Bicycle and Pedestrian School Safety Review Study

Assessment Report Sweetwater Elementary School *Port Orange, FL*

June 2, 2010

**Volusia County Metropolitan Planning Organization
Bicycle and Pedestrian School Safety Review Study**

Illustration 3: Motorists Parking on the Eastern Side of Sweetwater Elementary School Campus on Victoria Gardens Boulevard

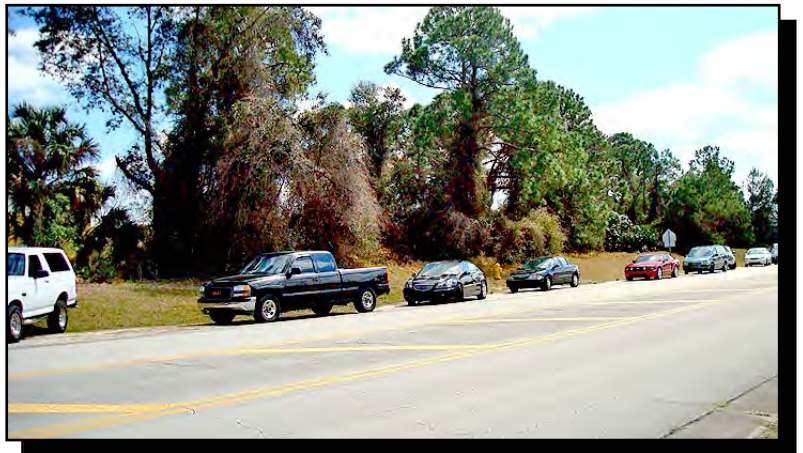
There is an existing safety concern that is caused by parents parking opposite the school premises on Victoria Gardens Boulevard, as shown in Illustration 3. They park across the street from Sweetwater Elementary School to avoid the waiting queue where the students are dropped-off or picked-up. The students cross Victoria Gardens

Boulevard without the aid of the crossing guard north of the intersection of Victoria Gardens Boulevard and Applevue Way. During the hours of arrival and dismissal, Victoria Gardens Boulevard is congested and unsafe for students to cross without the aid of a crossing guard, as shown in Illustration 4. Sweetwater Elementary School uses cones and NO PARKING signs in an attempt to dissuade parents from dangerous driving.

Illustration 18: No Level Landing or Ramp at the Intersection of Taylor Road and Boggs Ford Road

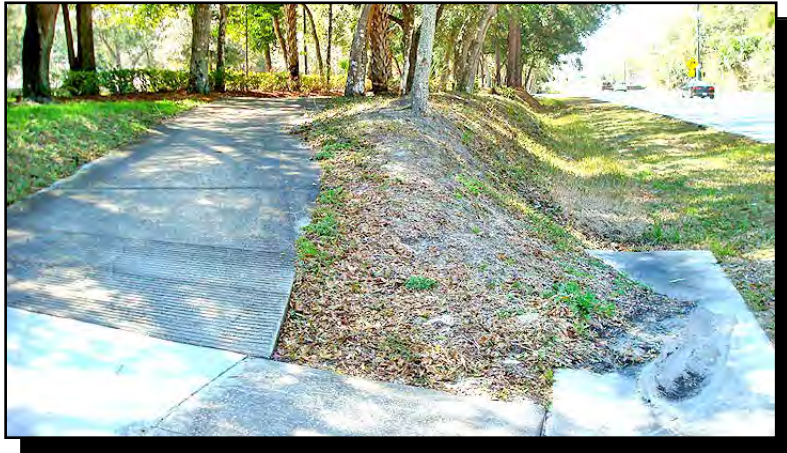
Observations: Boggs Ford Road and Taylor Road, currently a three-way intersection, has a continuous sidewalk on the southern side of Taylor Road. The southwest quadrant of the intersection at Taylor Road and Boggs Ford Road does not have a landing at the end of the vertical slope (see Illustrations 18-21).

Recommendations: According to the standards set by the ADA, the ramp should be constructed as follows:

- The landing shall be at least as wide as the ramp run leading to it
- The landing length shall be a minimum of 60 inches
- If the ramps change directions at landings, the minimum landing size shall be 60 by 60 inches

Detectable warnings should also be placed at the curb ramp under Index 304 of the FDOT Design Standards and the ADA for disability considerations.

Illustration 19: No Level Landing or Ramp at the Intersection of Taylor Road and Boggs Ford Road

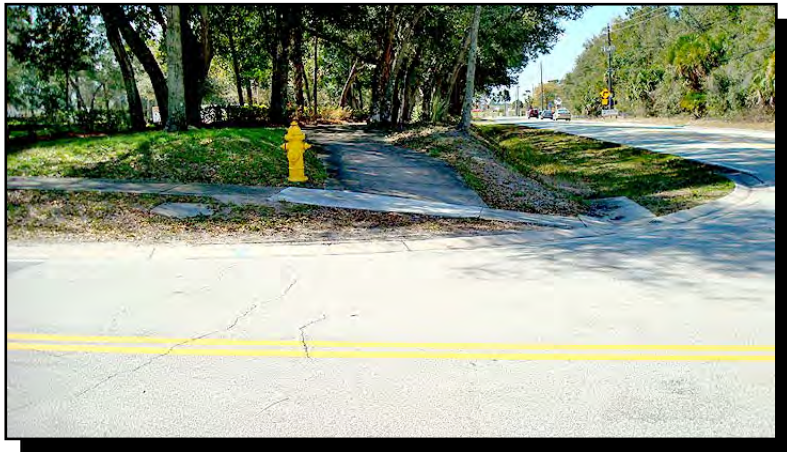
Observations: The sidewalk ends at a flume drainage feature, located in the southwest quadrant of Taylor Road and Boggs Ford Road (see Illustrations 18-21).

Recommendations: The sidewalk cannot end at the flume drainage feature for safety reasons. An ADA compliant grate, with spacings of no greater than ½ inch (13 mm) wide, should be placed over the flume drainage feature and the sidewalk built up around the grate.

The ADA also requires that a ramp should connect the sidewalk to the curb. The ADA guidelines recommend a ramp slope of 1:16 and 1:20 to provide a more safe and effective passage to the crosswalk.

It is recommended that a ramp be placed at the intersection of the two sidewalks in the southwest quadrant of this intersection. It is further recommended that crosswalk markings be added to connect the ramps on either side of Boggs Ford Road. This may require relocating the STOP line four feet south of the crosswalk markings.
